Metro South-West Joint Development Assessment Panel Agenda

Meeting Date and Time: 2 October 2015; 10:00am
Meeting Number: MSWJDAP/80
Meeting Venue: City of Rockingham
Civic Boulevard,
Rockingham

Property Location:	Lot 159 Minden Lane, Baldivis
Application Details:	Mixed Use Development (Showroom, Gymnasium and Office)
DAP Name:	Metro South West JDAP
Applicant:	Planning 4Site Pty Ltd
Owner:	Staub Family Pty Ltd
LG Reference:	20.2014.373.001 (D15/97801)
Responsible Authority:	City of Rockingham
Authorising Officer:	Mr Bob Jeans, Director Planning & Development Services
Department of Planning File No:	DAP/14/00631
Report Date:	2 September 2015
Application Receipt Date:	19 September 2014
Application Process Days:	370
Attachment(s):	<ol style="list-style-type: none">1. Second JDAP deferral2. First JDAP deferral3. Site and Ground Floor Plan (Drawing SK.12 Rev J)4. First Floor Plan (Drawing No. SK.13 Rev J)5. Second Floor Plan (Drawing No. SK.14 Rev J)6. Elevation and Section Plan (Drawing No. SK.15 Rev I)7. Perspective Plan8. Urban Design Advice9. Approved Detailed Area Plan10. Applicant's Additional Information

Figure 5 – Revised (Current) Site and Ground Floor Plan (8.6.2015)

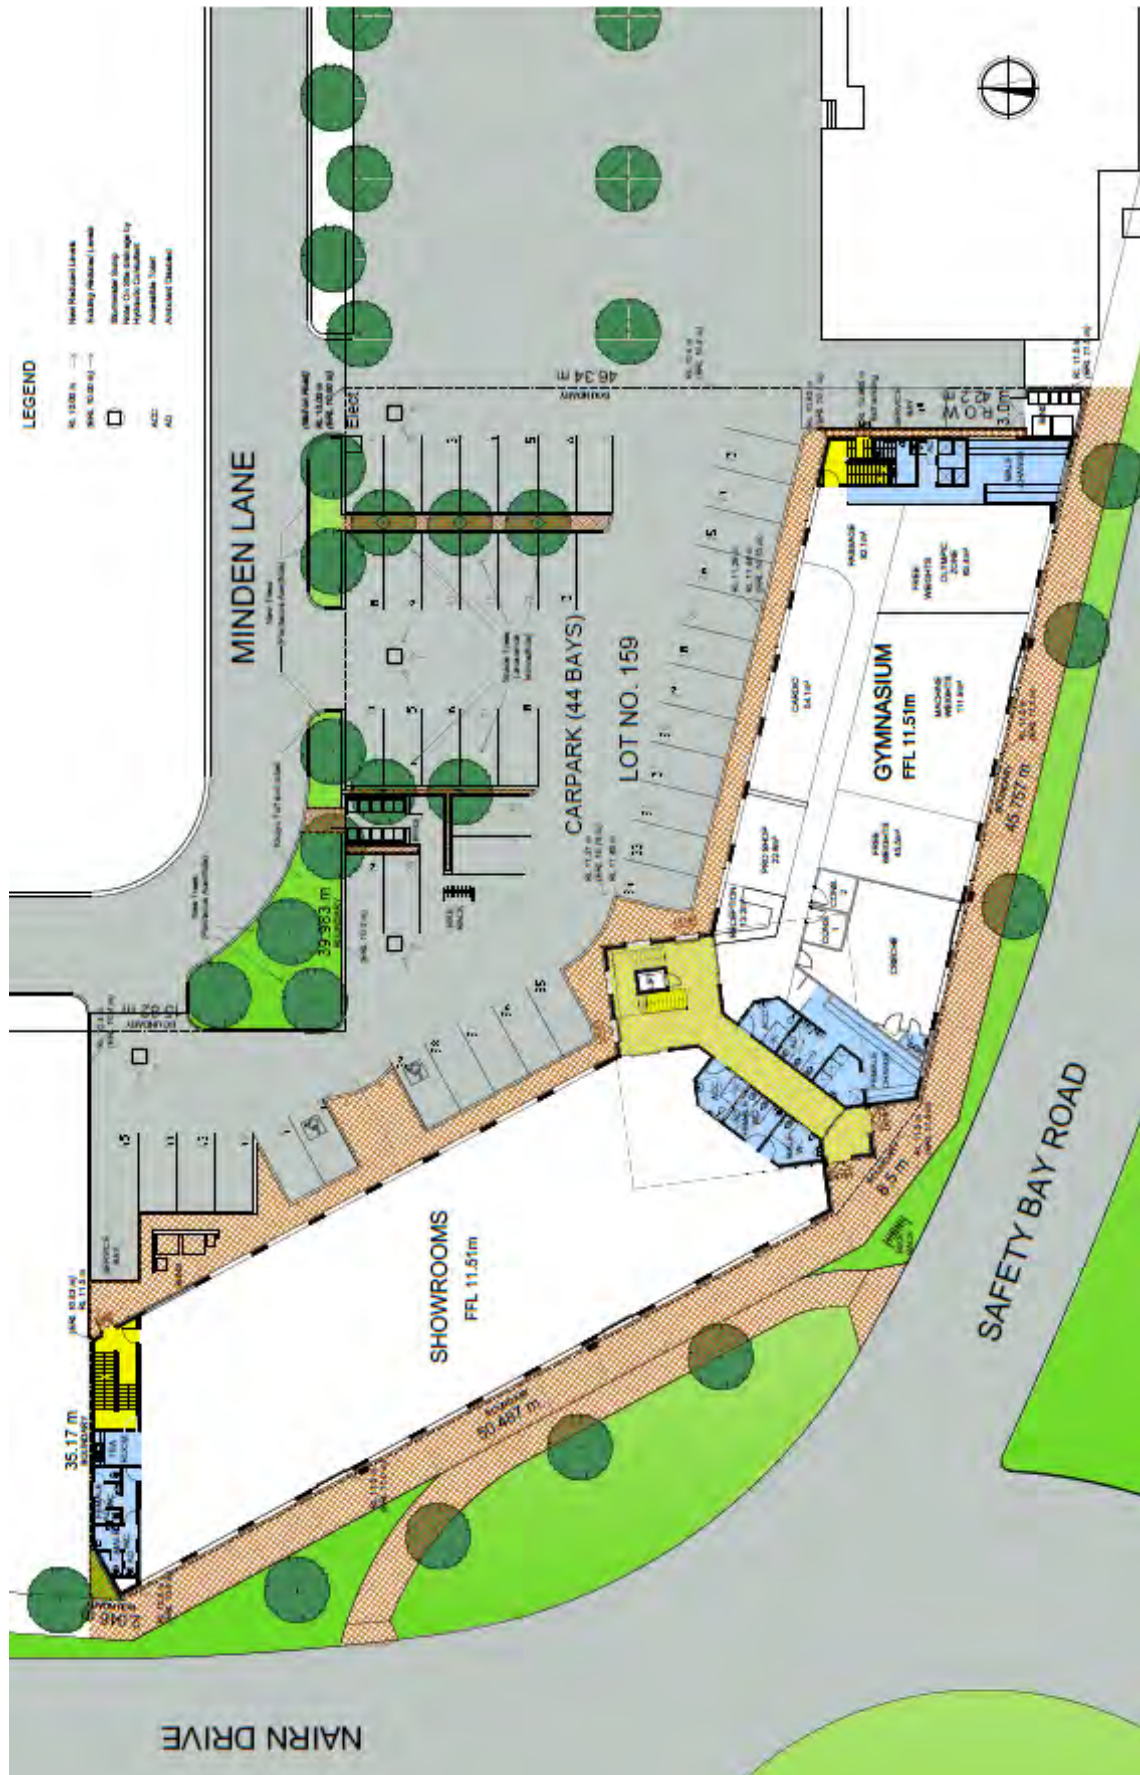
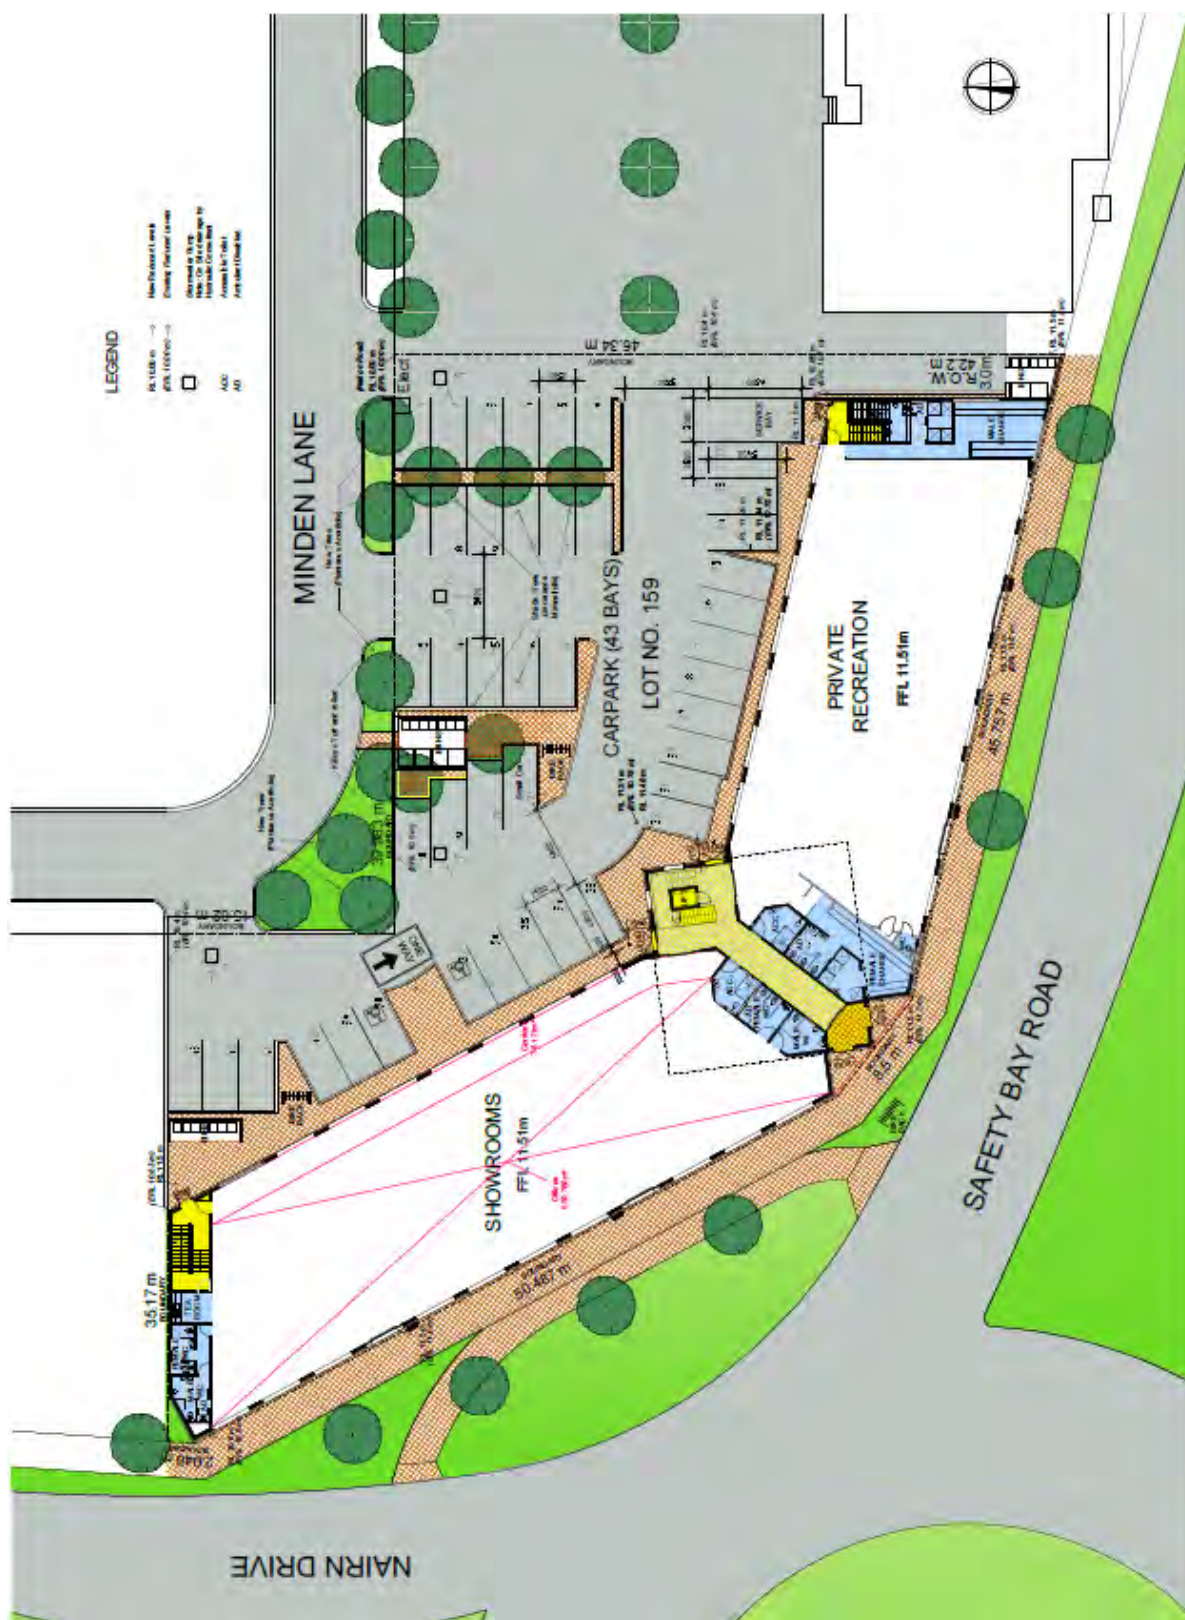
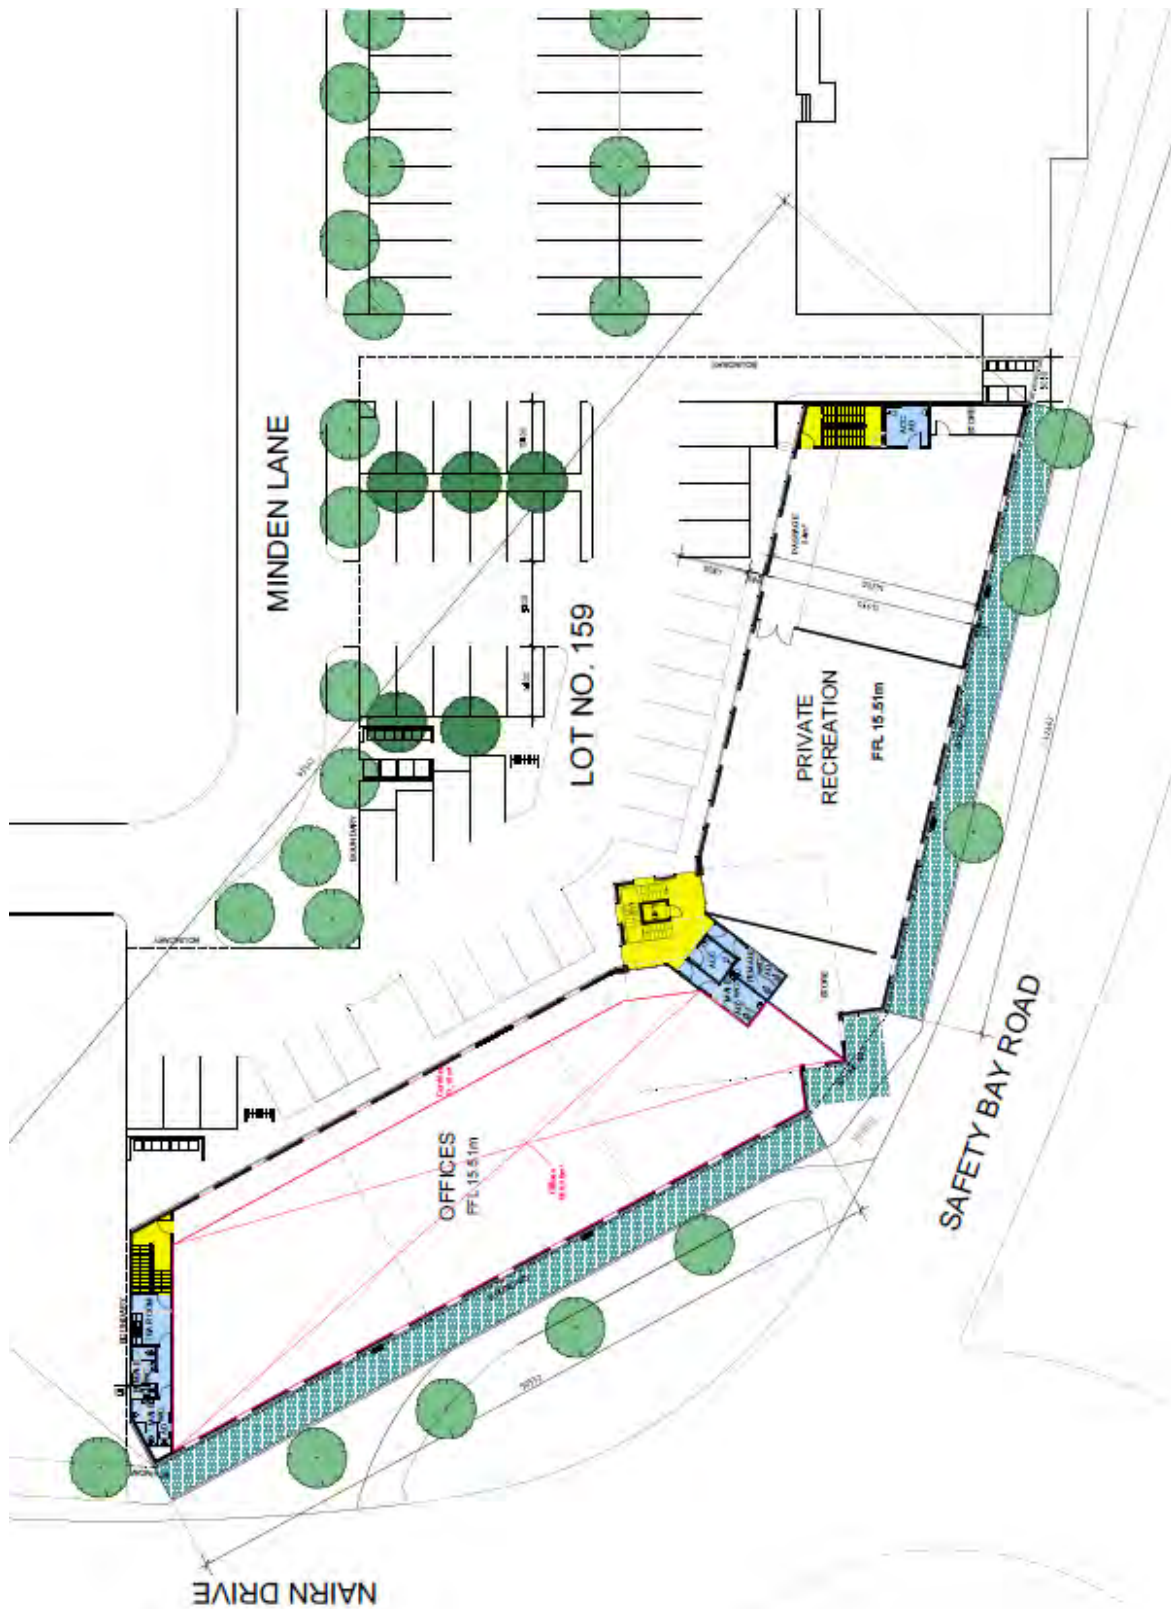
1. Refuse the DAP Application reference 20.2014.00000373 as detailed on the DAP Form 1 dated 19 September 2014 and accompanying Site and Ground Floor Plan (Drawing No.SK.12 Rev J), First Floor Plan (Drawing No.SK.13 Rev J), Second Floor Plan (Drawing No.SK.14 Rev J) and Elevation and Section Plans (Drawing No.SK.15 Rev I), dated 8 June 2015 in accordance with the provisions of the Town Planning Scheme No.2 and the Metropolitan Region Scheme, for the proposed mixed used commercial development at Lot 159 Minden Lane, Baldivis for the following reasons:

- (a) The proposed development fails to make adequate provision for car parking, including parking for people with a disability, as it does not comply with the parking requirements of clause 4.15.1.1 of the Town Planning Scheme No.2 and clause 8 (b) of the approved Detailed Area Plan.

- (c) Adequate provision has not been made for the loading, unloading, manoeuvring and parking of vehicles, as required by clause 6.6 (q) of TPS2.
- (d) The proposed development does not provide sufficient variety and articulation of street front building facades as required by clause 7.4.3 (iv) of the City's Local Planning Policy 3.2.4 – Baldivis Town Centre.

- Change in land use in the western ground floor tenancy from a showroom to an office; *(The City contends that this change cannot be considered as it would constitute a material change to the proposal, and was not included in the scope of the deferral reasons. It would require a new development application);*

- The following changes have been made to the original development plans:
 - Site and Ground Floor Plan:
 - § Reconfiguration of the carpark layout resulting in a loss of four (4) car bays (deletion of one (1) car bay and conversion of three (3) bays to small car bays). This results in an overall parking provision of 43 parking bays (inclusive of three (3) small car bays and two (2) accessible parking bays);

Figure 6 - Revised (Current) First Floor Plan (8.6.2015)

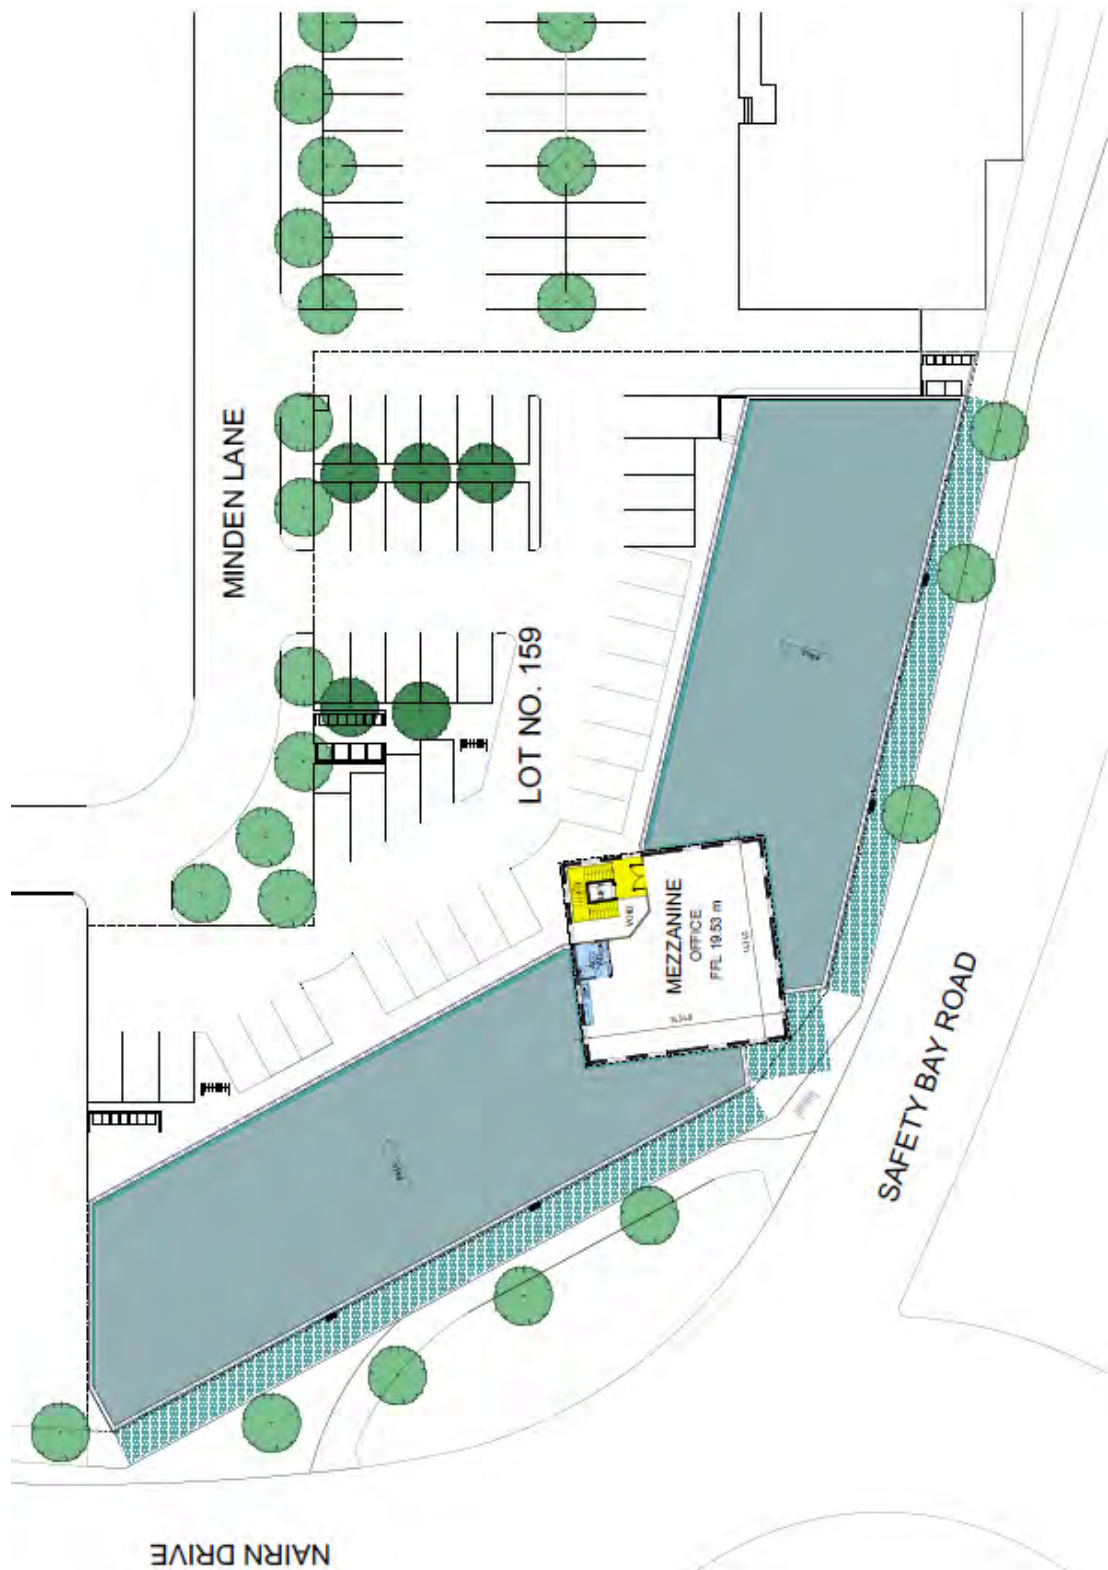
- § Deletion of the division and delineation of internal floor area for gymnasium.
 - First Floor Plan:
 - § Identification of a 77.15m² corridor adjacent to the rear wall of the proposed office; and

Figure 8 – Revised (Current) Safety Bay Road Elevation (South Western) (8.6.2015)

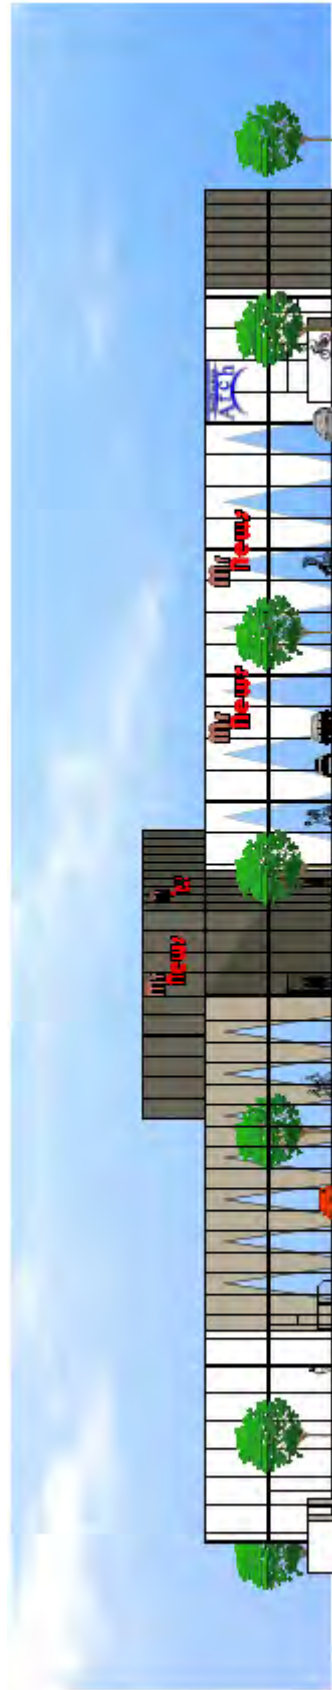
- § Reduction in building depth of 0.1m at the rear of the building.
 - Elevations and Section plan
 - § Increase in the width of the vertical elements by 0.1m on the street elevations.

On the advice of the JDAP (deferral reason no.2) the applicant amended the street elevations by increasing the width of the vertical elements by 100mm. This change is considered to be extremely minor. The proposed development is characterised by its lack of variety. Excessive repetition is found in the:
